Faiza Industries Ltd. Extended Building

R.S - 425, Baimail, Konabari, P.O.- Kashem Cotton Mill, Thana- Joydebpur, Gazipur
(24.006853, 90.337155)
1st October 2020

Buildings Information

Observations

Observations: Production Building-2

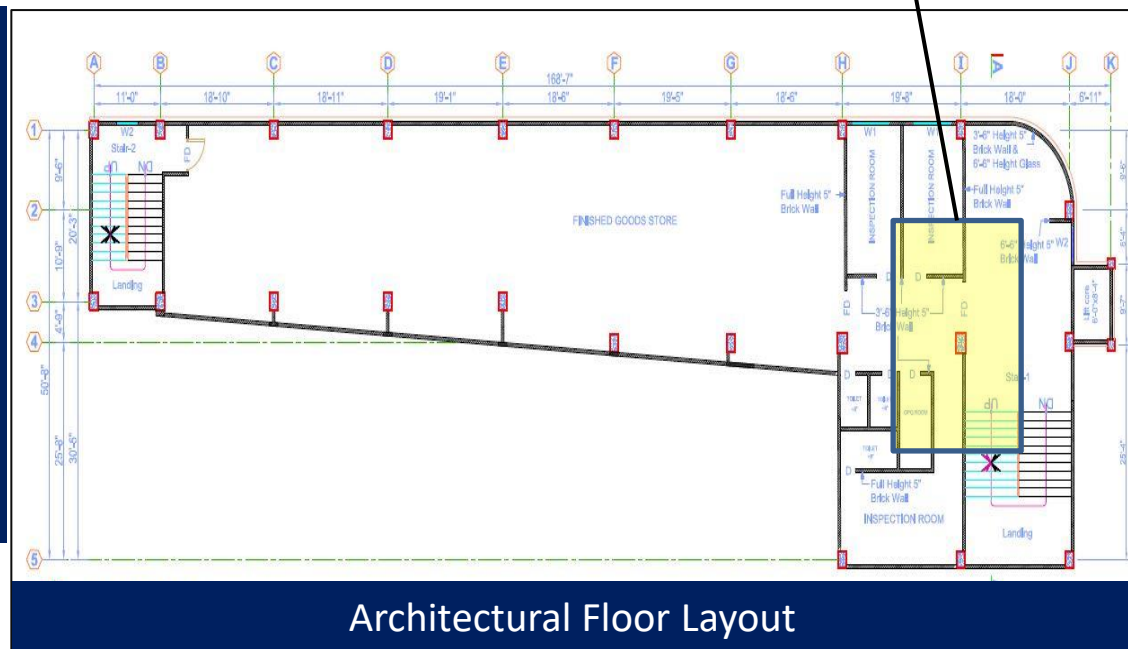
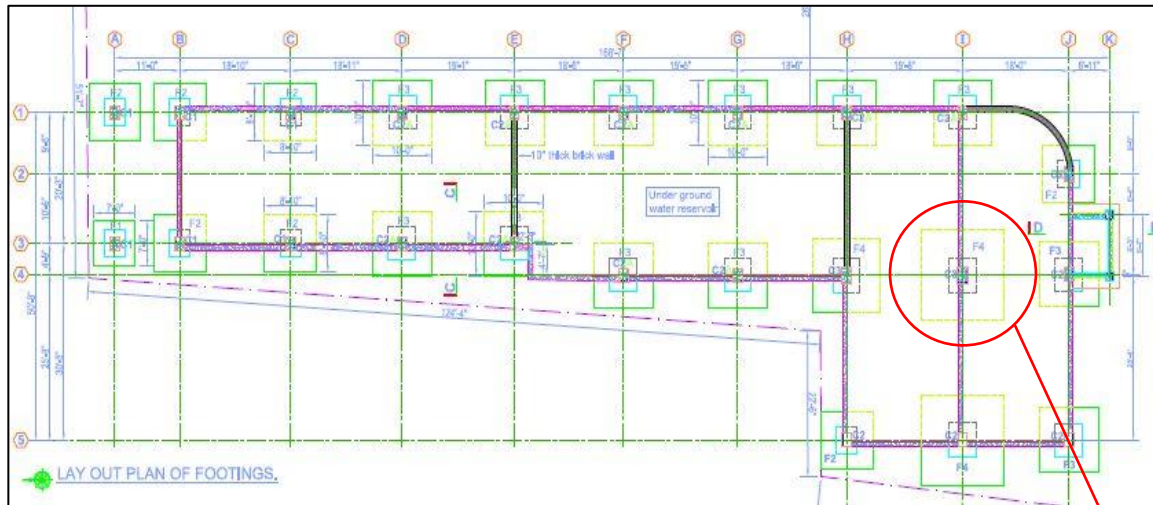
Cursory calculation indicates that column is stressed above normal design limits considering 5 kPa live load on typical floor & minimum concrete strength for stone chips. Building Engineer to review design, loads and columns stresses. Also, prepared load plan need to be revised based on floor, column and foundation capacity.

Footing Layout Plan.

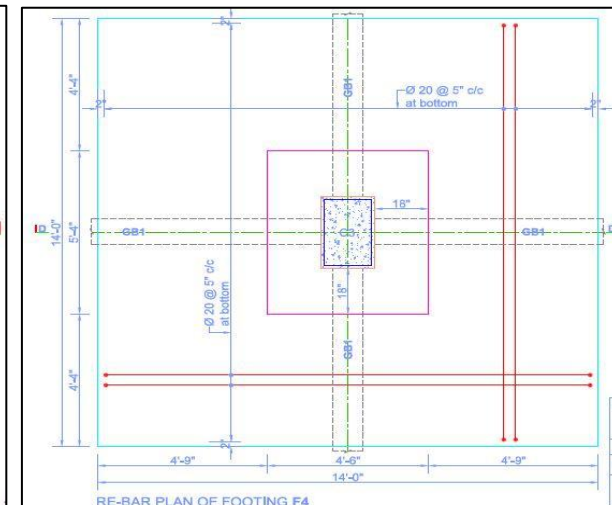
Punching shear capacity check was performed for the footing-F4. Footing thickness is 750 mm (at punching critical zone). Column size 525X775 mm (below ground level).

Footing section

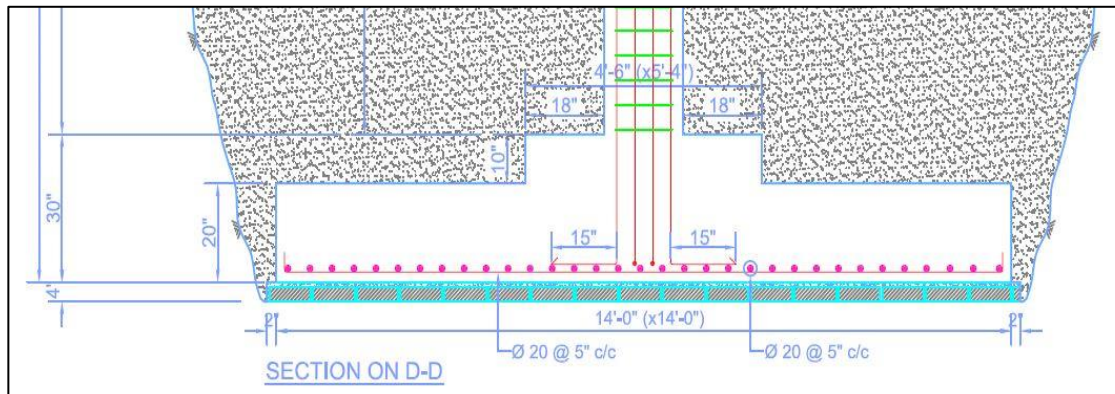
Cursory calculation indicates that footing thickness is inadequate to resist punching shear considering minimum concrete strength for stone chips. Factory engineer is required to review the adequacy of footings and comply with BNBC.
